SUPPLEMENTAL RESPONSE TO REQUEST FOR ADDITIONAL INFORMATION

APR1400 Design Certification

Docket No. 52-046

RAI No.: 274-8277
SRP Section: 7.1 - Instrumentation and Controls
Application Section: 7.1, 7.3, and 10.2
Date of RAI Issue: 10/27/2015

Figure 7.2-4 CEA Position Signal Flow for CPCS

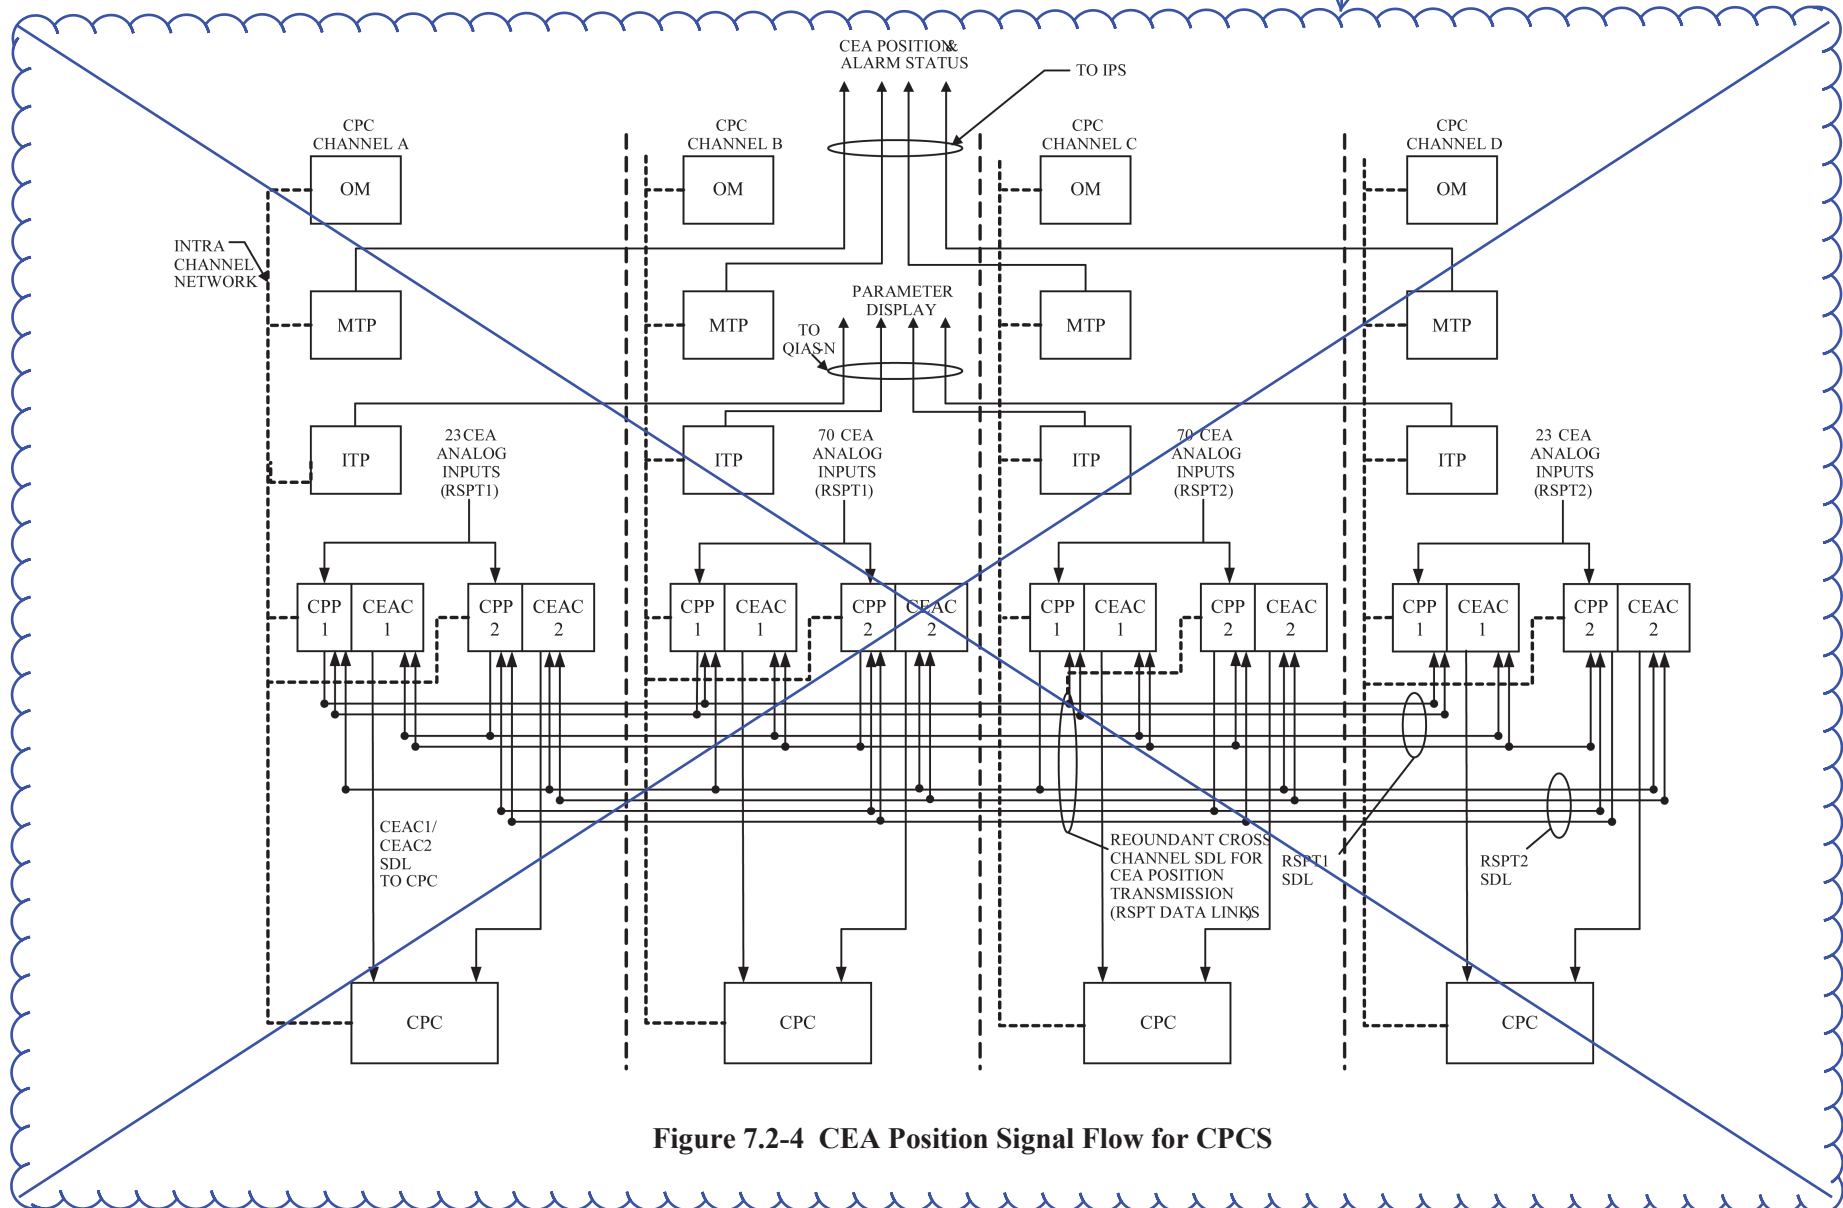
In addition, DCD Tier 2, Figure 7.2-4, "CEA Position Signal Flow for CPCS," will be modified because it was missing a CPP output signal from the Channel D CPP1 module.

The figure will be replaced with the next page.

Table 7.2-7 and Figure 7.2-4 of DCD Tier 2 will be revised, as indicated in the attachment associated with this response.
